SUBJECT: Minor amendment to 1975 Mine Plan

DIKE MAINTENANCE POND V

POND SYSTEM FIVE DIKE

Enclosure - Map

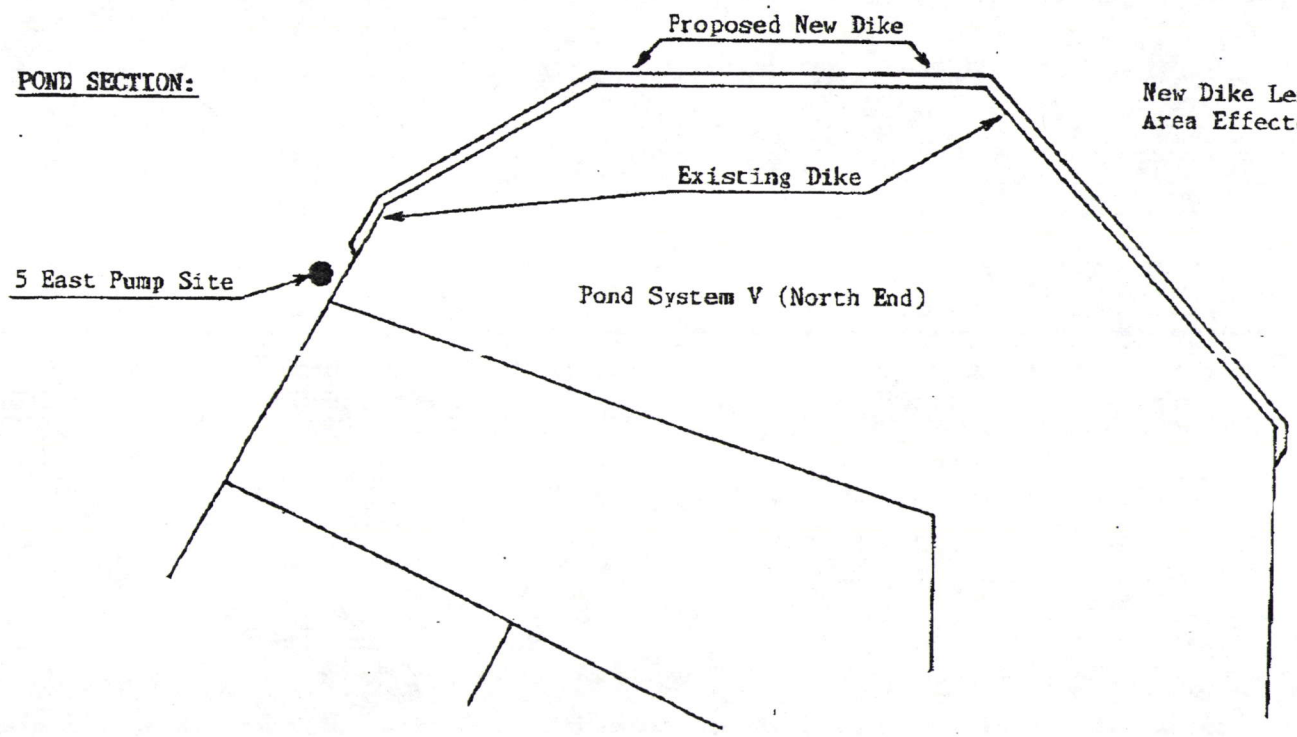
Pond system five has been in production since about 1978. It was designed and constructed on a twenty year life. Since this was the first pond to be constructed on a twenty year life, the actual life was not known. Reilly Wendover has in the last few years performed maintenance on the perimeter dike. At the close of this evaporation season the perimeter dike was evaluated. The north end of the dike is in very bad condition and requires immediate attention.

The berm (A see map) is too narrow for a dragline and the borrow is too wide for a dragline to set (B see map) and reach the dike. Therefore it has been proposed to go outside the borrow approximately 250 feet (see map) and construct a new cut-off dike. The new dike would be 14,300 feet long and 15 feet high. It would be of the same design and construction as the original dike in pond system five.

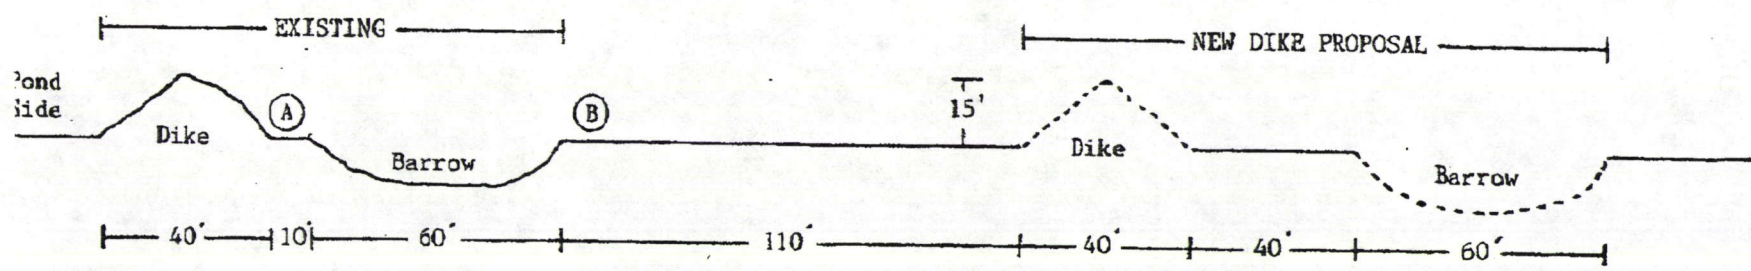
New Dike Length: 14,300 ft. (2.7 mile)
 Area Effected: 82.07 Acres
